**Pacific Gas and  
Electric Company**

PG&E Letter DCL-04-131

Docket No. 50-275, OL-DPR-80  
Docket No. 50-323, OL-DPR-82  
Diablo Canyon Units 1 and 2  
License Amendment Request 04-05  
Revision to Technical Specification (TS) Requirements for Handling Irradiated Fuel in the Primary Containment and the Fuel Handling Building and Selected Specifications Associated with Performing Core Alterations

Figure 3.4.16-1

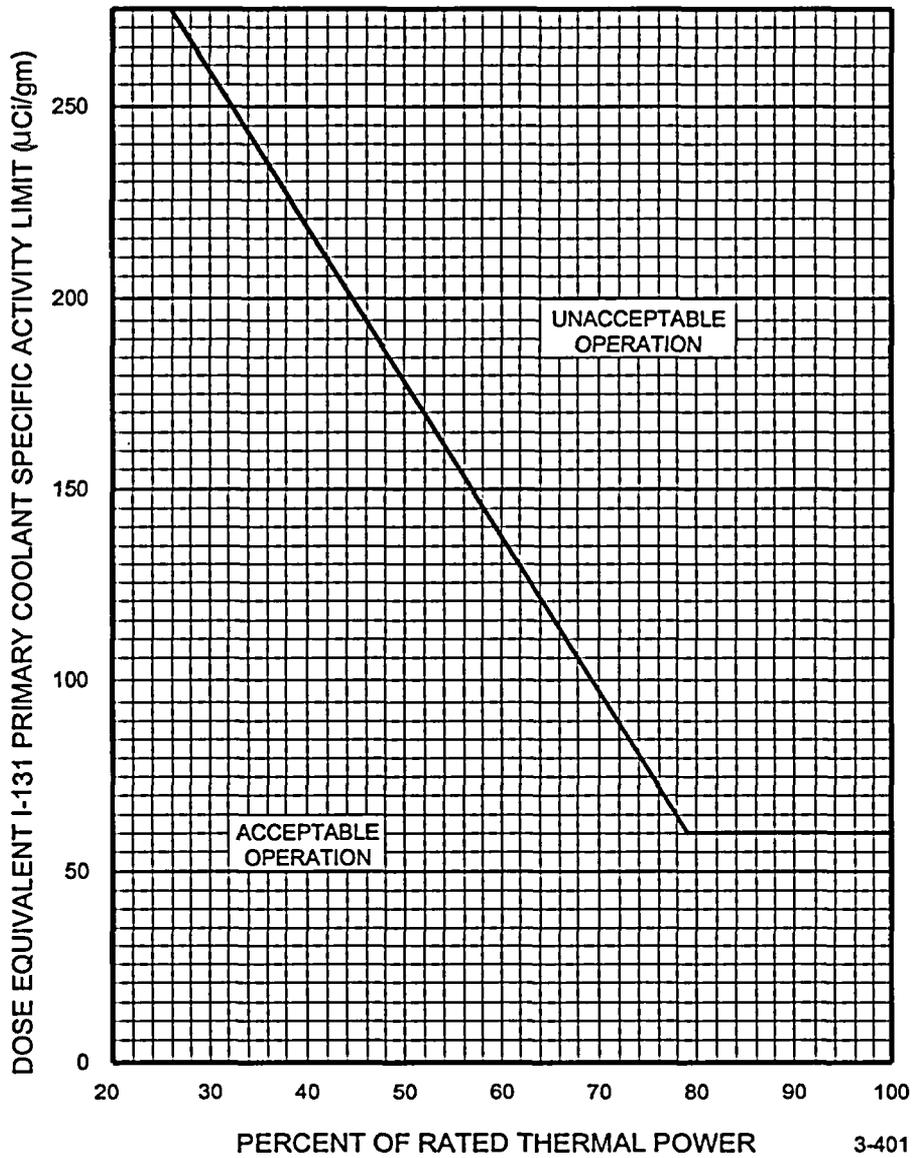
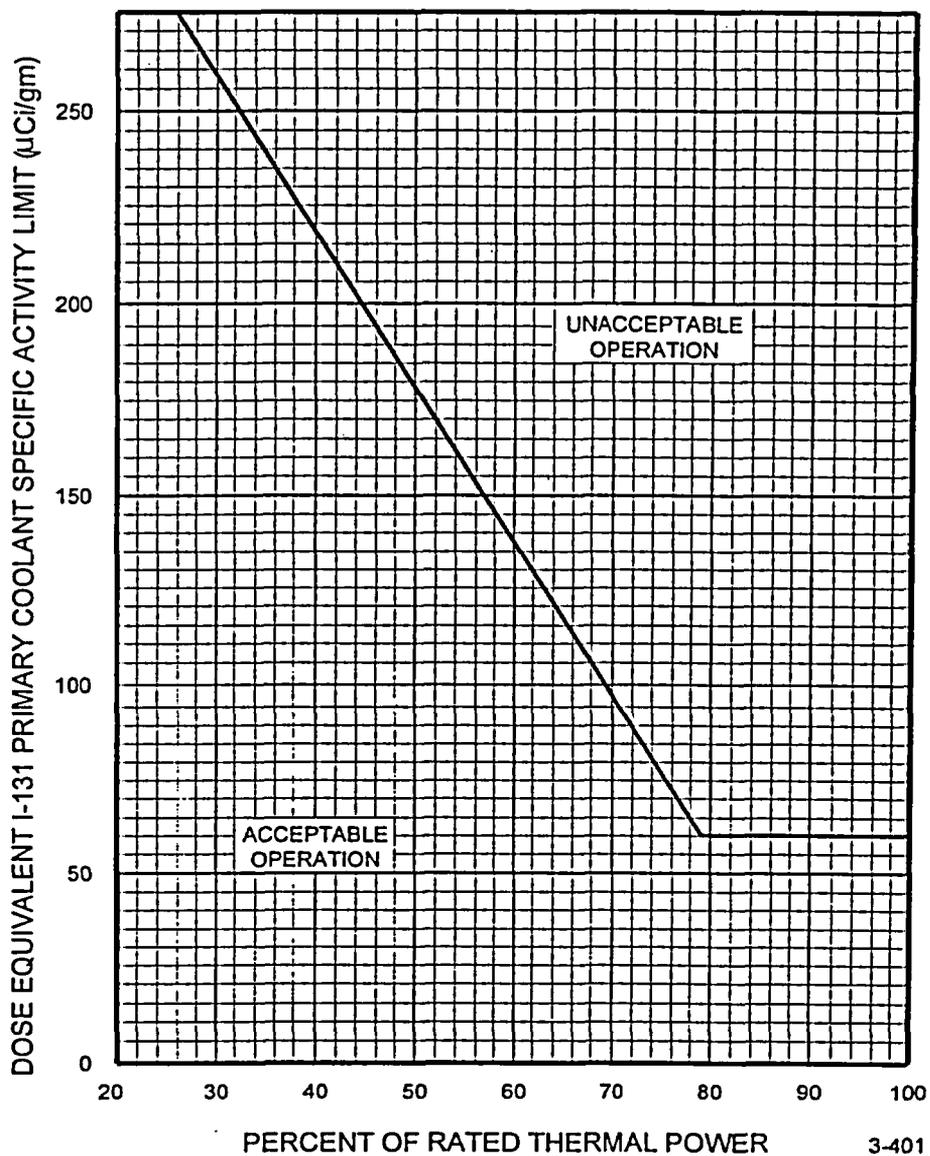
Figure number 3.4-1, "Dose Equivalent I-131 Reactor Coolant Specific Activity Limit Versus Percent of Related Thermal Power With the Reactor Coolant Specific Activity > 1 $\mu$ Cl/Gram Dose Equivalent I-131," is corrected to 3.4.16-1.

Figure number 3.4-1 of TS 3.4.16 was incorrectly numbered during the implementation of the Improved Technical Specification Program, License Amendments (LA) 135/135 (Reference 3), and is being corrected to figure number 3.4.16-1.
